**GENOA CHARTER TOWNSHIP  
PLANNING COMMISSION  
PUBLIC HEARING  
JUNE 9, 2014  
6:30 P.M.  
AGENDA**

**OPEN PUBLIC HEARING #1...** Review of site plan application and impact assessment for an 8,000 square feet Medical Building, located at a vacant lot on Grand River, Brighton, Parcel # 4711-14-200-023, south of Grand River between Hubert and Grand Beach. The request is petitioned by Howard Lipkin.

<b>Attention:</b>	Mike Archinal, AICP Township Manager
<b>Subject:</b>	Lipkin Medical Office Building – Site Plan Review #2
<b>Location:</b>	Grand River Avenue – south side of Grand River, west of Hubert Road
<b>Zoning:</b>	NSD Neighborhood Services District

**Re: Lipkin Medical Building  
Site Plan Review #2**

TITLE: **SITE PLAN**

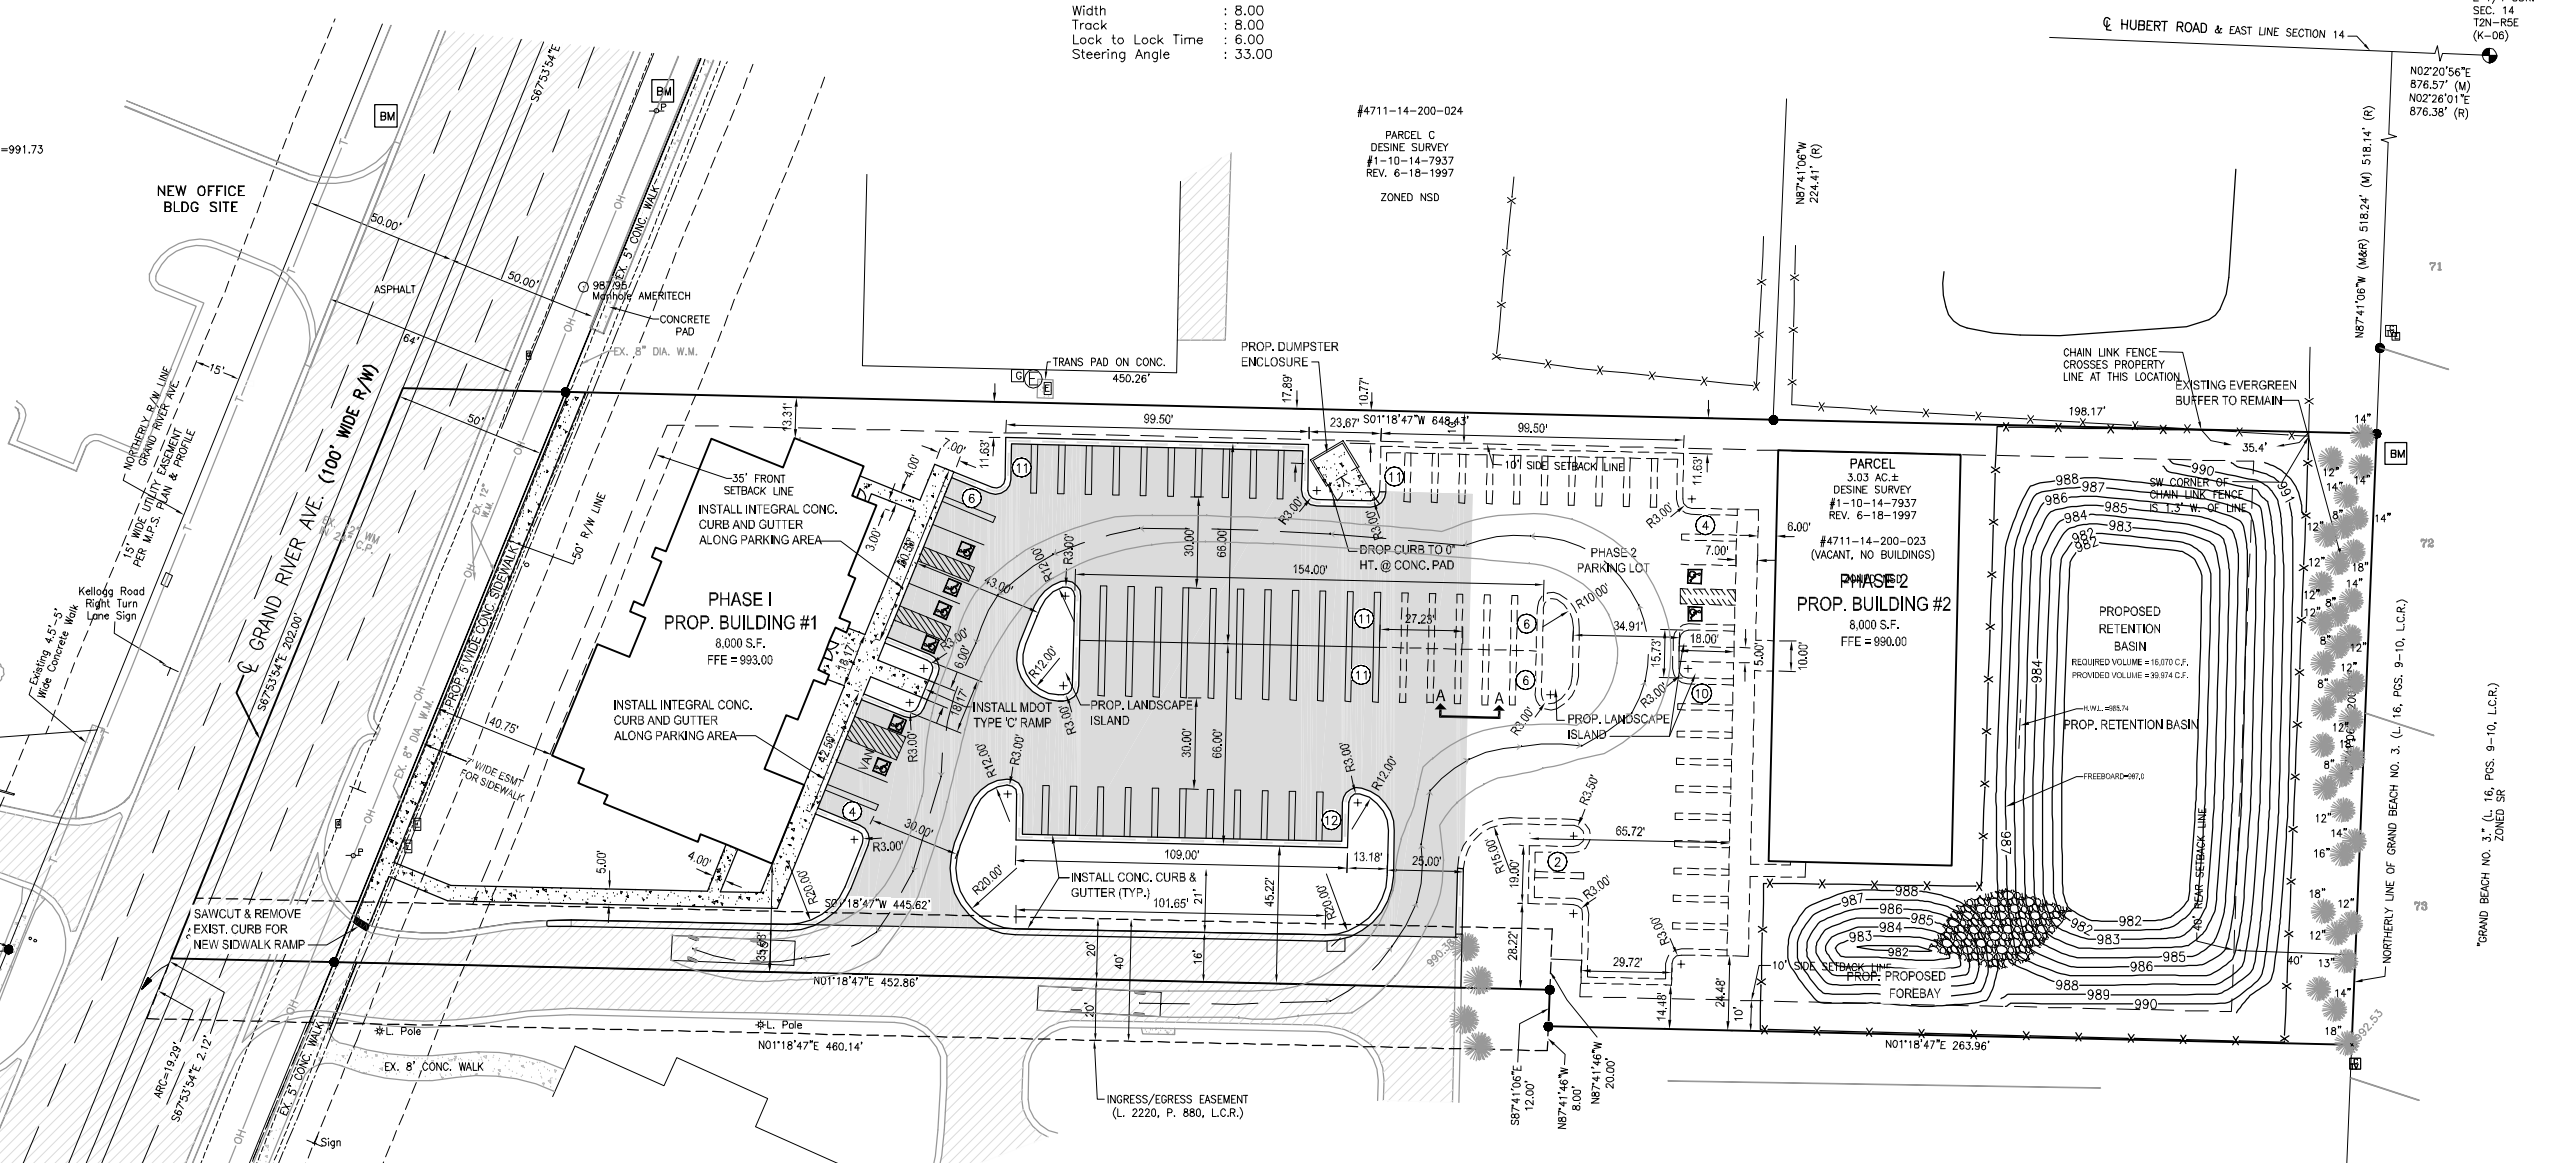
2. Existing public utilities and sizes have been labeled on the plan.
3. The proposed 5' wide sidewalk along the Grand River Ave. frontage has been moved southerly to 1' outside the Road Commission right-of-way to align better with the existing walks on each side of the our side lot lines. A 7' wide sidewalk easement has been added to the plan.

4. Cross section details have been added to the site plan showing the proposed Phase 1 and Phase 2 butt joint construction at the southern edge of pavement. The proposed edge of asphalt has been moved 2' to the south, to allow a proper future butt joint which will serve as a break point for the overall parking lot drainage. Refer to Sheet 8 which now shows interim drainage and erosion control in the Phase 2 portion of the site.

**TITLE:** UTILITY PLAN

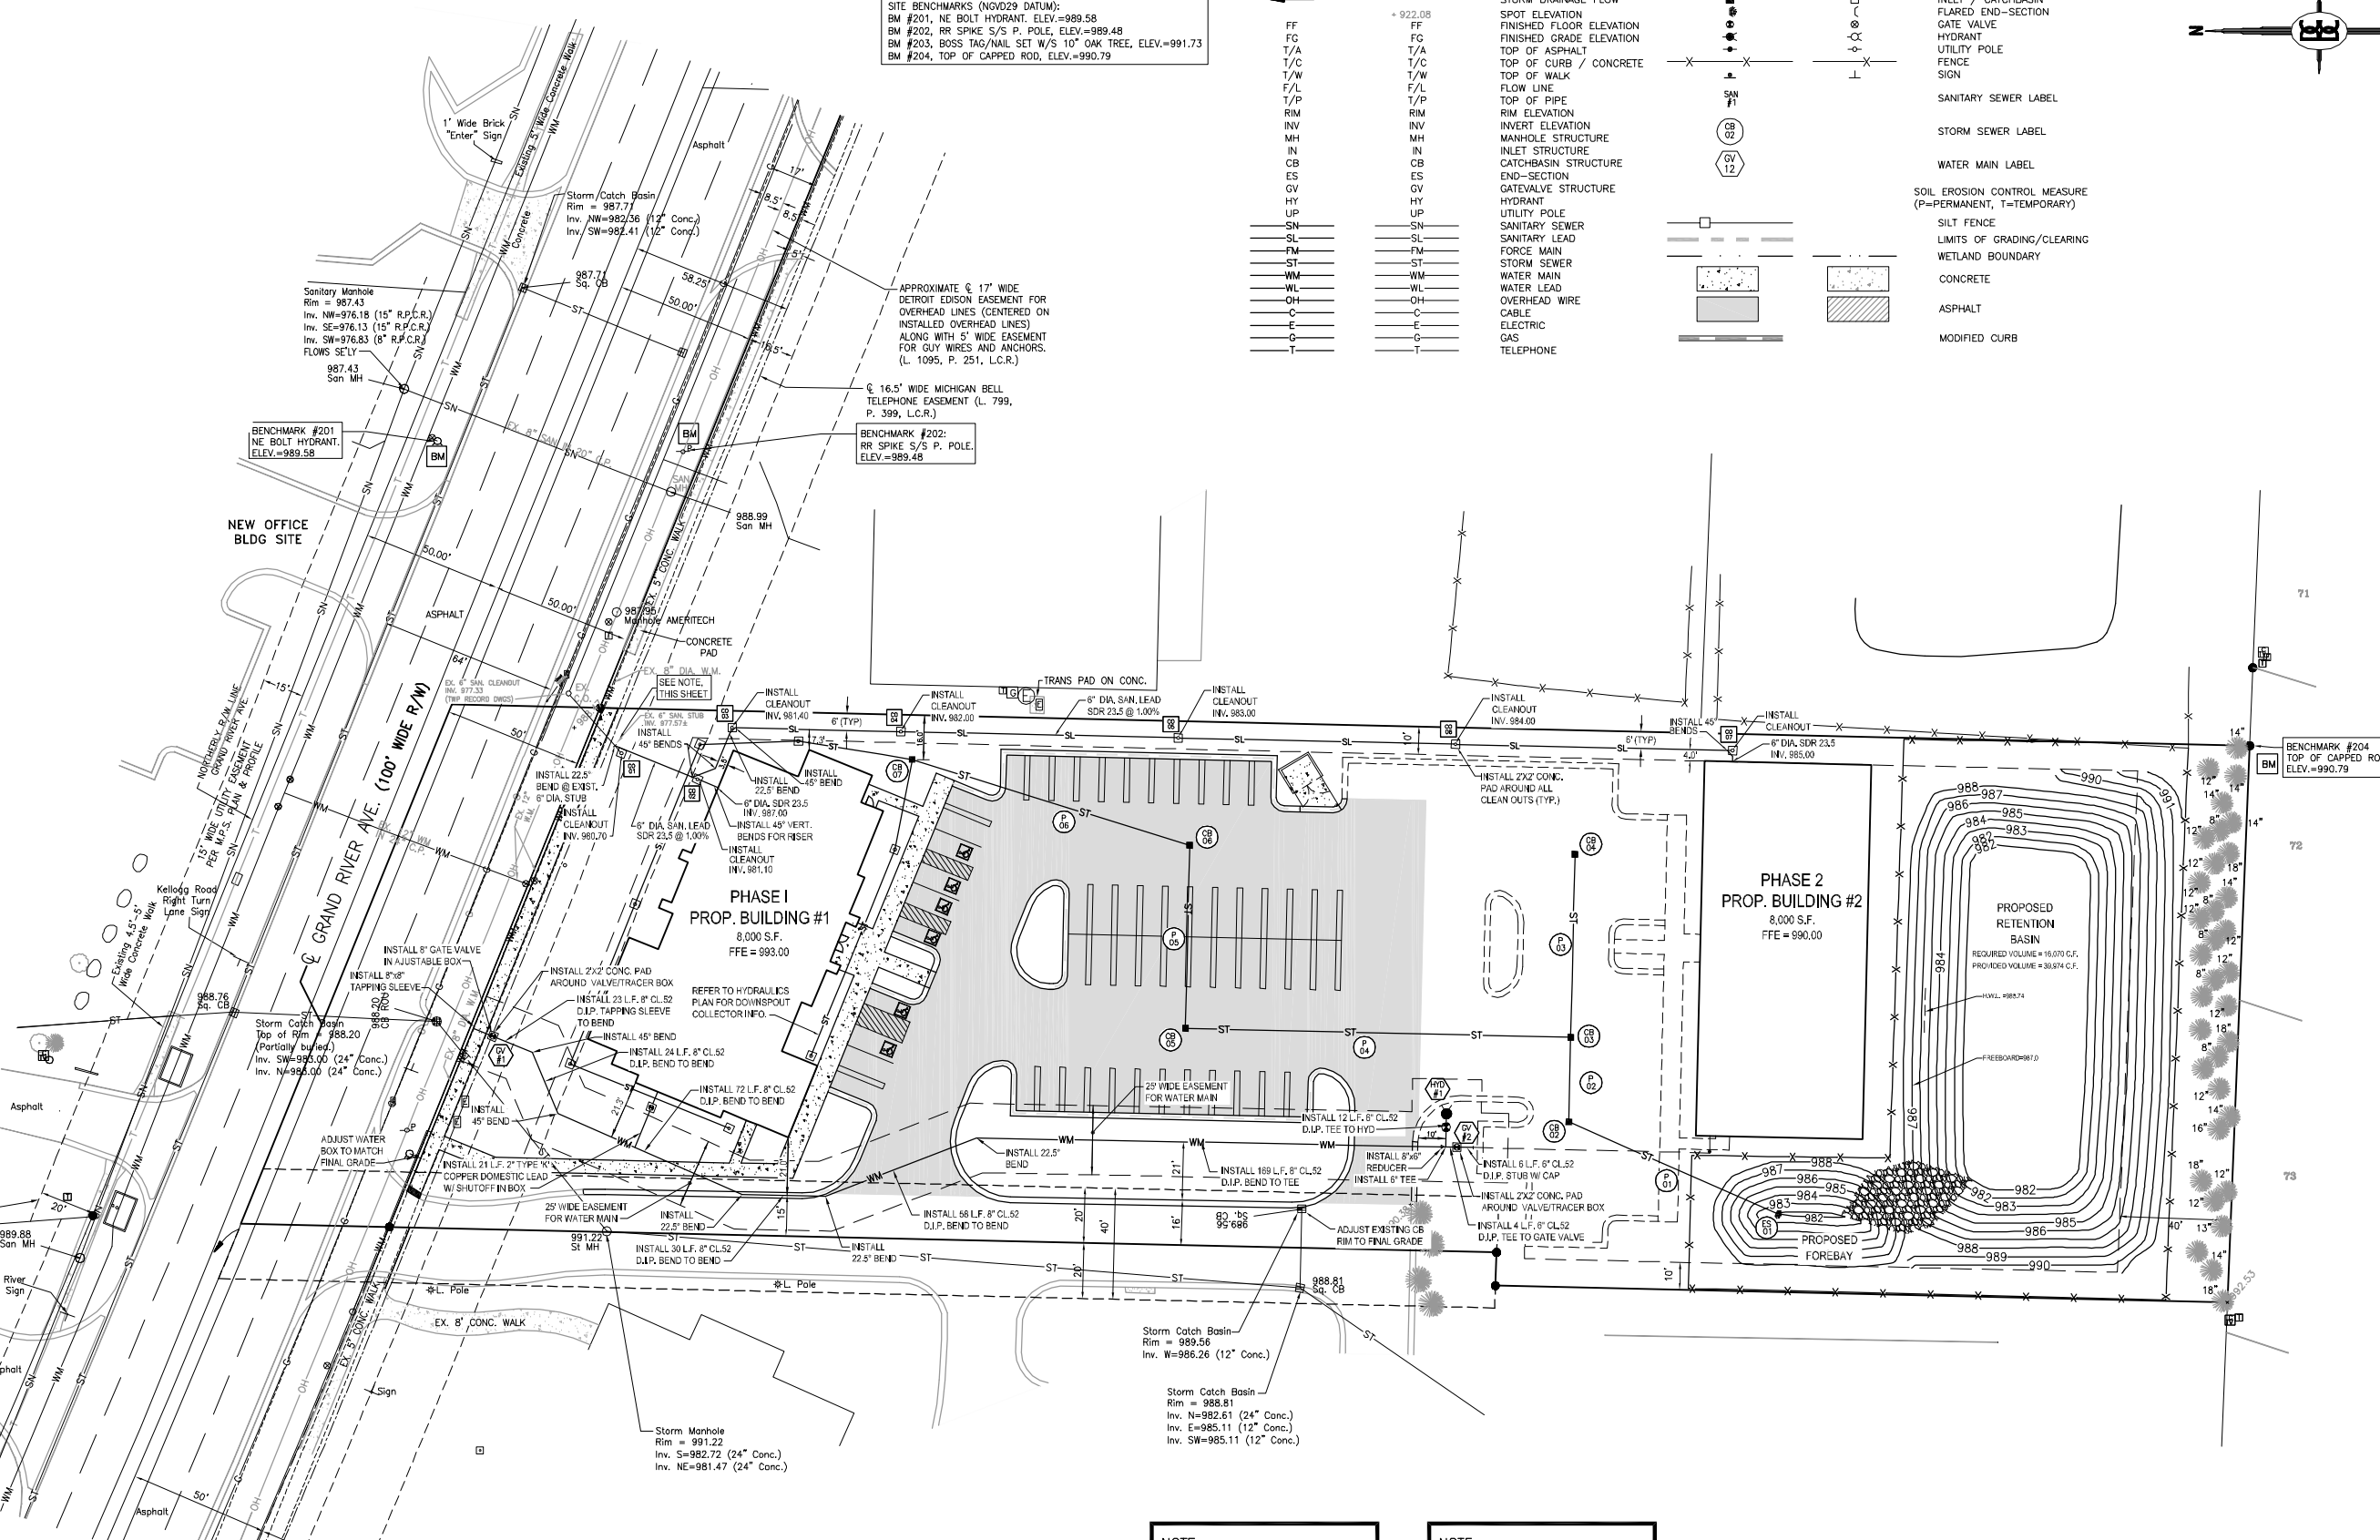
1. The developer has indicated that there will be no fire suppression system in either building, only 2-inch water service connections. Please label the size of the future water main beyond the proposed 6" cap. As the minimum diameter for a public main is 8-inches, it is recommended to install an 8-inch by 6-inch tee at the hydrant. If a 2-inch service is the only piping planned for building 2, then a plug could be installed with a 2-inch threaded opening for the future 2-inch shutoff valve. This would eliminate the need for a 6-inch gate valve.

1. An 8"x8" Tapping Sleeve note has been added to the Utility Plan and the 12" reference on the profile sheet has been revised to show 8" water main in street. The relocated hydrant at the driveway entrance has been removed from the drawing, since the existing location does not interfere with the newly relocated sidewalk.

2. Lengths and dimensions have been revised on the Utility Plan. Also, refer to the profile for additional utility lengths.
3. The water main notes have been revised to show that the water main is at least 21.0' away from the corner of the building (ie. 20' from the footing).
4. We have confirmed with Tetra Tech that the water flow rate in the existing 8" water main in Grand River Ave. is 130GPM at an average pressure of 60psi, which should be sufficient for domestic service to the two buildings since they will not incorporate an internal fire suppression system.
5. Construction plans will be submitted to MHOG for review and permitting.

TITLE: **LANDSCAPE PLAN**

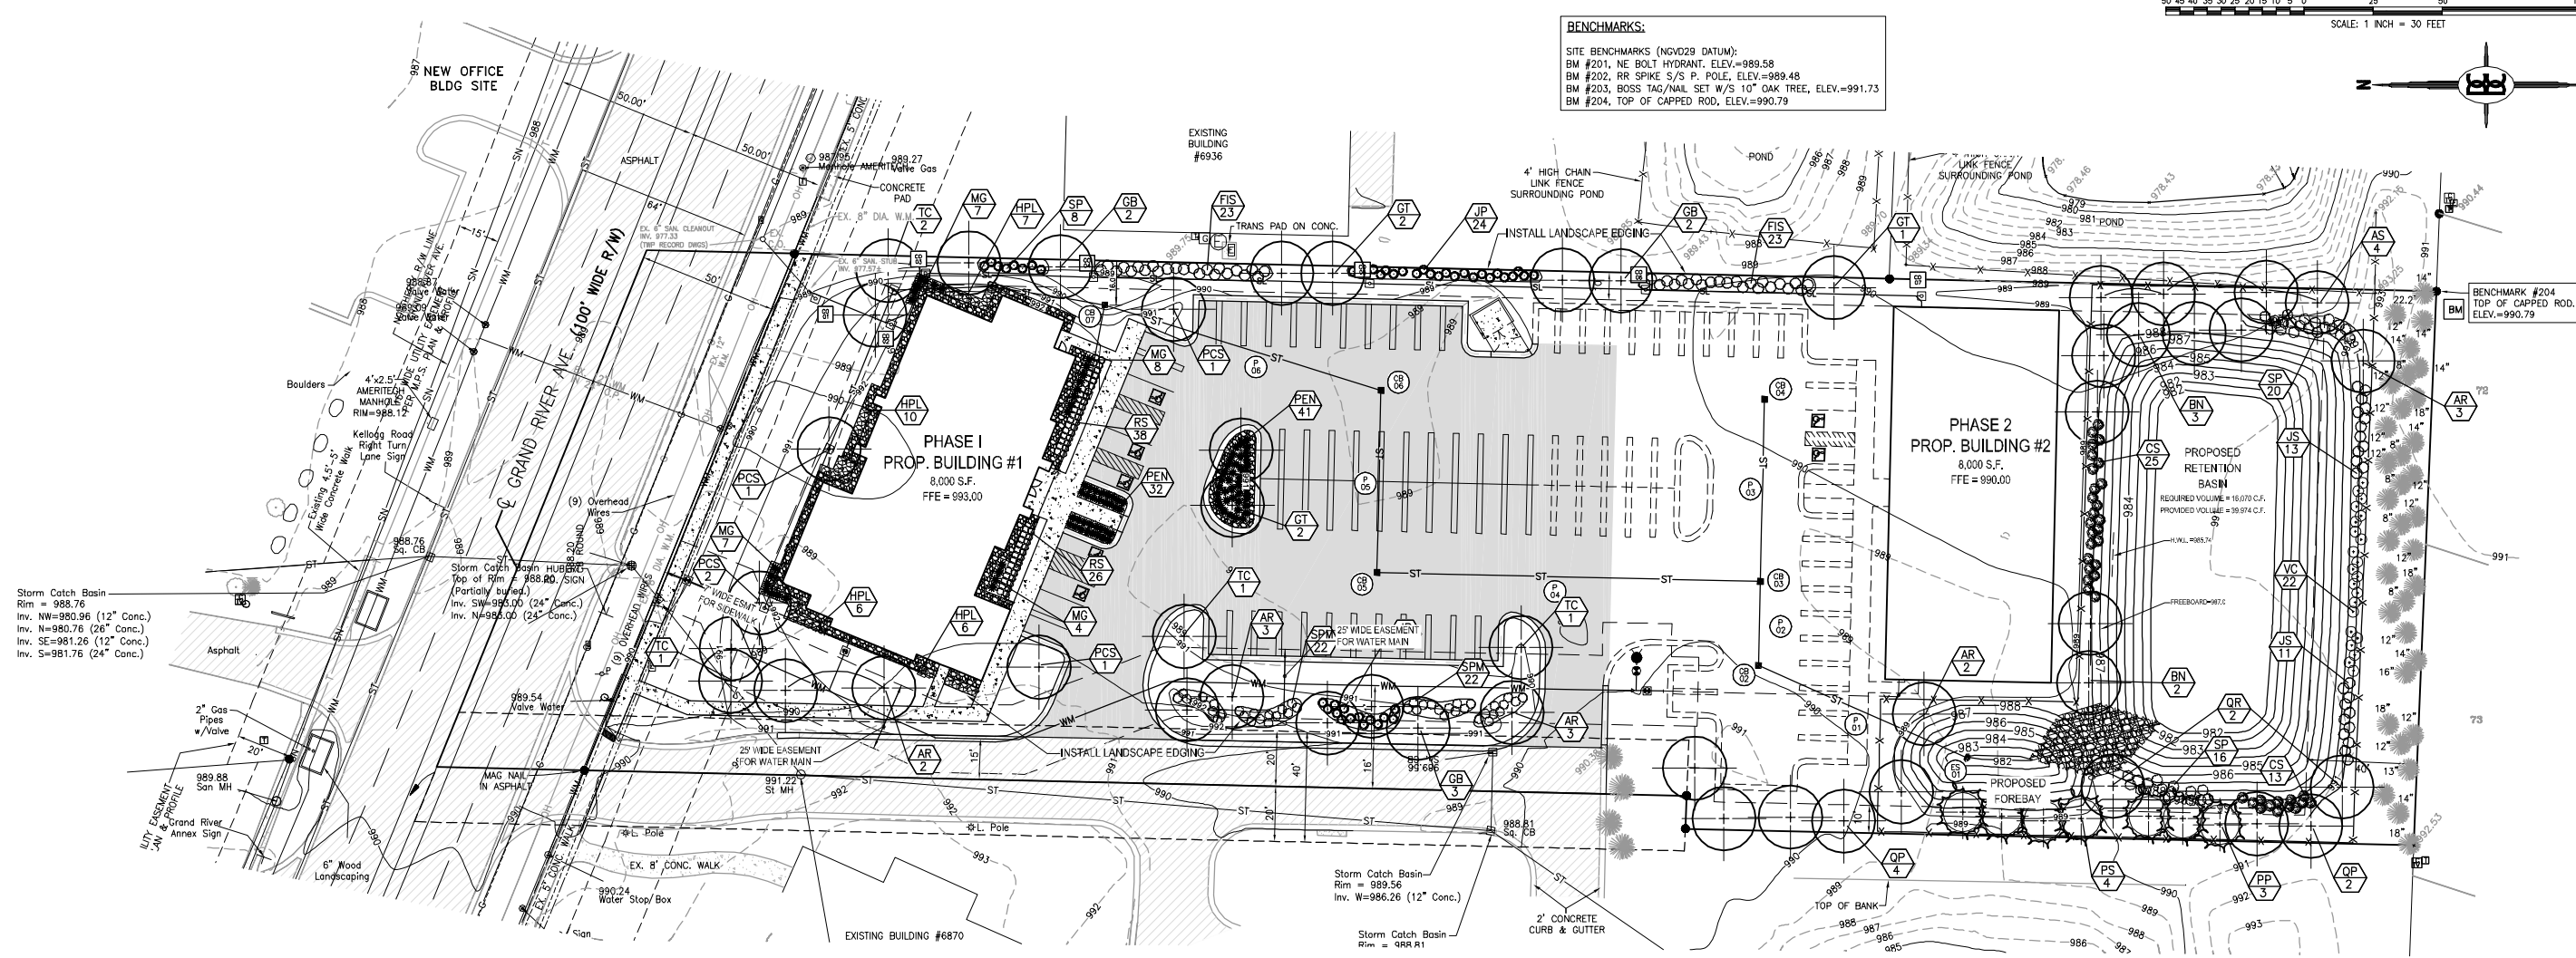
There are two minor discrepancies between the landscape plan and table on Sheet C5. Specifically, the table notes 10 Red Sunset Maple, which are accounted for; however, there appears to be an errant label on the westerly parking lot island for an additional 3 trees. Additionally, the 14 Aurea Juniper label appears to be hidden behind the water main label on the same landscape island.

7. Additional landscape plantings have been added along the east property to bring the design into ordinance compliance.
8. The minor discrepancies in the landscape plan have been corrected.
